APPEAL SUMMARY

Appeal ID: 23799	Project Address: 1006 SE Salmon St
Hearing Date: 6/10/20	Appellant Name: Mark Annen
Case No.: B-008	Appellant Phone: 503 239 4834
Appeal Type: Building	Plans Examiner/Inspector: Renay Radtke Butts
Project Type: commercial	Stories: 2 Occupancy: F-1, S-1,B Construction Type: III-B + V-B
Building/Business Name: Coava Coffee	Fire Sprinklers: No
Appeal Involves: Alteration of an existing structure	LUR or Permit Application No.: 20-139380-CO
Plan Submitted Option: pdf [File 1] [File 2]	Proposed use: F-1 (Industrial) S-1 (Storage) + B (accessory offices)

WAREHOUSE RENOVATION
COAVA COFFEE
1006 SE SALMON ST., PORTLAND, OREGON 97214

Date	06/03/2020
Scale	VARIES
Drawn	MJA
	WINDOW APPEAL
Sheet	
Of	AP.2 Sheets

2. EAST ELEVATION - REPLACEMENT WINDOW

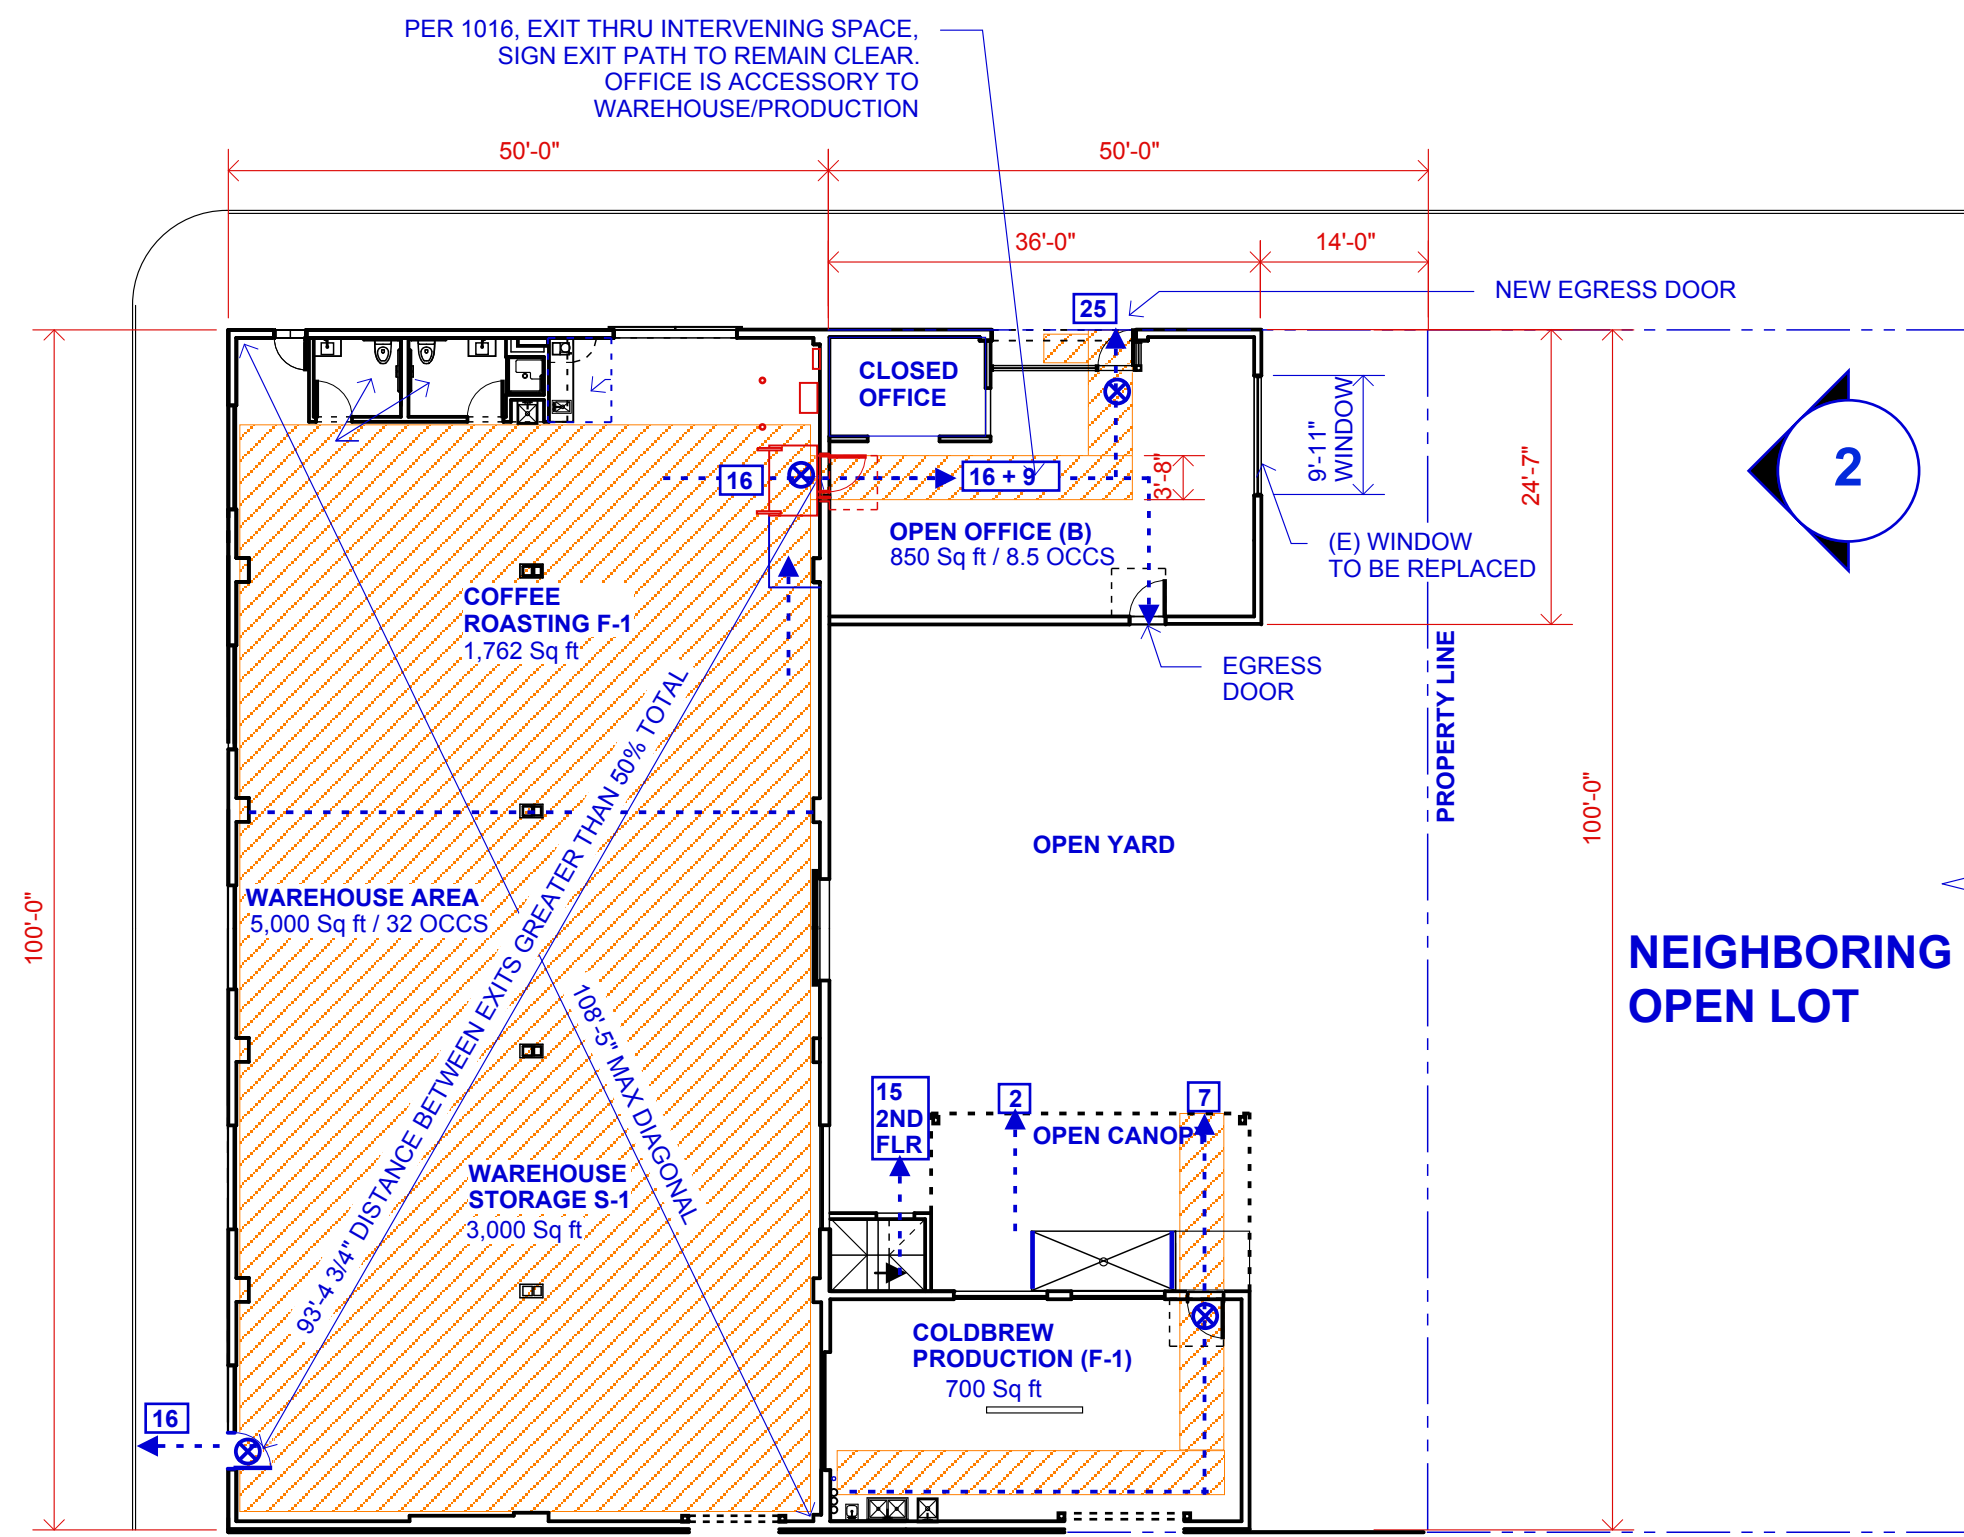
Requires	Table 705.8 Fire Separation distance: 10 to less than 15' - Unprotected, Nonsprinklered - Allowable Area =15% Existing East wall 14' from property line is 341.1 sq. ft., 15% is 51.2 sq. ft. allowable area.
Code Modification or Alternate Requested	Allow replacement in existing 85 sq. ft. (25% allowable area) concrete window opening with a smaller window (76 sq. ft., 22% allowable area) and 1 hr. rated concrete header at top. New window would meet current energy code and decrease the existing opening size though still slightly over the 15% allowance.
Proposed Design	Existing window opening was built at time when allowable per code. Building is Type III-B Shipping Room (F-1) containing accessory office area per historic permits. Change to Offices (B) with multiple egress doors (one added) and total occupancy of 25. Use of area only slightly altered and we propose to reduce existing opening with new double paned commercial glazing of noncombustible materials to current energy code.

Reason for alternative	While still slightly over the 15% prescribed allowable area we are reducing the existing area and replacing with a better window. Improvement in structural capacity with new header, improvement in energy conservation with double pane glass in commercial storefront frame. Life safety improvement with additional egress door from offices. At 14' from property line we are only 1' away from the 25% allowance per table 705.8 while we are reducing existing opening from 25% to 22% in the proposed window.

TOTAL WALL AREA = 341.1 SQ. FT.
ALLOWABLE OPENING IS 15%
341 x 0.15 = 51.2 SQ FT
EXISTING OPENING IS 85 SQ. FT. (25% OF AREA)
PROPOSED OPENING IS 76 SQ. FT. (22% OF AREA)

2. Increase in maximum allowable exterior wall opening: Granted as proposed.

For Item 2: The Administrative Appeal Board finds that the information submitted by the appellant demonstrates that the approved modifications or alternate methods are consistent with the intent of the code; do not lessen health, safety, accessibility, life, fire safety or structural requirements; and that special conditions unique to this project make strict application of those code sections impractical.
